NUREG-1911, Rev. 3

NRC Periodic Compliance Monitoring Report for U.S. Department of Energy Non-High-Level Waste Disposal Actions

Annual Report for Calendar Year 2010

Office of Federal and State Materials and
Environmental Management Programs

Figure 2: INTEC TFF Monitoring-Well Network (from DOE-Idaho, 2010)

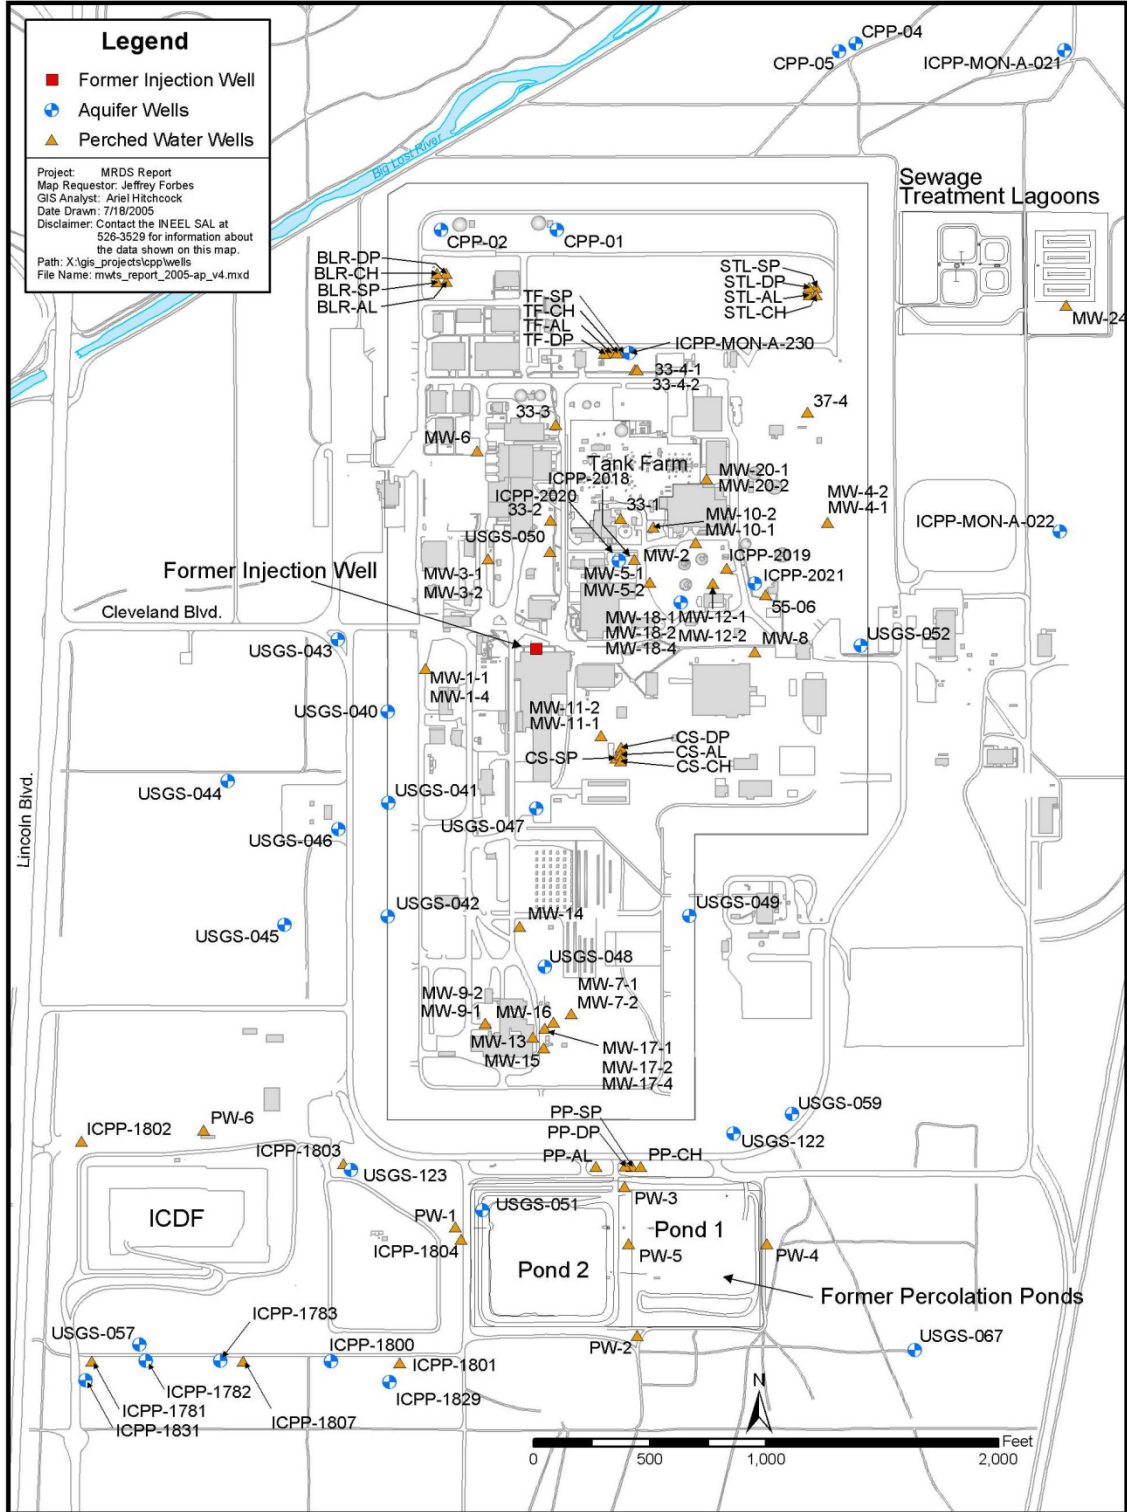
Consistent with previous data, the highest Tc-99 concentrations were associated with monitoring well ICPP-MON-A-230 (2,220 pCi/L) located near the INTEC Tank Farm and the second-highest Tc-99 concentrations were measured at aquifer well ICPP-2021 (1,240 pCi/L), located southeast of the Tank Farm (see Figure 2 above). These two wells were the only wells to exceed the Tc-99 MCL of 900 pCi/L. ICPP-2020 was the only well that showed a significantly higher Tc-99 level (382 pCi/L) than was reported in previous years (e.g., 215 pCi/L in FY 2007). All other wells showed stable or declining trends.

Consistent with previous data, very high Sr-90 levels (>10,000 pCi/L) were observed in the northern shallow perched water across INTEC. The highest Sr-90 concentrations were observed in wells southeast of the Tank Farm. The maximum Sr-90 concentration detected was 130,000 pCi/L at monitoring well ICPP-2018 (see Figure 2). At most well locations, Sr-90 concentrations were similar to those observed during the previous year, but are approximately half those reported in the same wells during the mid-1990s due to decay and transport. Gross beta activity was detected at nearly all perched water sampling locations with the highest gross beta level occurring at well ICPP-2018 (311,000 pCi/L) consistent with the Sr-90 data.

The lateral extent of the northern shallow perched water was mapped in the FY 2009 report (DOE-Idaho, 2010). Shallow perched water wells MW-8, MW-11-2, MW-12-2, and MW-18-2 were essentially dry (<0.15 m [0.5 ft] of water) during the monitoring period. The Big Lost River flowed past INTEC between June 18 and July 4, 2009. However, only one monitoring well (Well BLR-CH) showed a significant water-level response to the river flow event. Well BLR-CH is the well closest to the river (i.e., 152 m [500 ft] from the river channel). After a 4-day time lag following the onset of flow in the river, the perched water level in Well BLR-CH rose 6.7 m (22 ft) over 16 days. This is essentially the same water-level response observed in the past at this well location. No other wells showed any response to flow changes in the river.

Figure 1: Disposal Cell Depiction (not to scale)

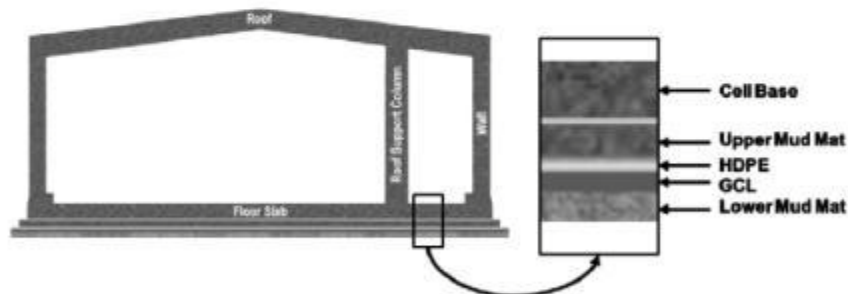
around the base of the cell (Figure 1). Due to the presence of damp spots on cell 2B, the hydrostatic test of cell 2B was postponed and investigations were performed to determine the source of the spots.

The NRC staff visited the site to observe the progress of examining the root cause of the damp spots. At the time of the observation, the vendor CROM was in the process of removing the outer layer of shotcrete on the outside base of the cell at the points exhibiting damp spots. In addition, spots noticed at a lower point (between the upper mud mat and the cell floor, note Figure 1) provided sufficient evidence for portions of the upper mud mat to be removed enough to see the circumference of the cell floor under the base of the cell. SRR staff walked NRC staff around the circumference of the cell and requested multiple photos be taken at various points during this portion of the tour (available at ADAMS accession number ML101460045). In all, 33 damp spots were identified at various spaces around the circumference of the cell. These spots were slightly damp to the touch, but were mostly evident by sight. NRC staff asked various questions pertaining to the timing of the damp spots and any correlations the location of the spots had with construction materials, components, etc. that might have been noticed by SRR or CROM staff. A question of note asked by NRC staff was what effect the presence of damp spots will have on the hydro-test procedures, specifically, will any chemical or visual tracers be used in future hydro-tests (e.g. cell 2A hydro-test). SRR staff responded to the question by saying that insertion of a tracer will be considered for the hydro-test of cell 2A. Damp spots are of interest to the NRC staff because their unexpected presence and the corrective actions to repair them could each have some effect on assumptions made in the performance assessment pertaining to vault performance.

A red dye tracer was then added to the water to distinguish between water inside the cell and water from the surrounding environment, outside the cell.

The NRC staff will continue to monitor actions being taken to investigate the cause of the spots.
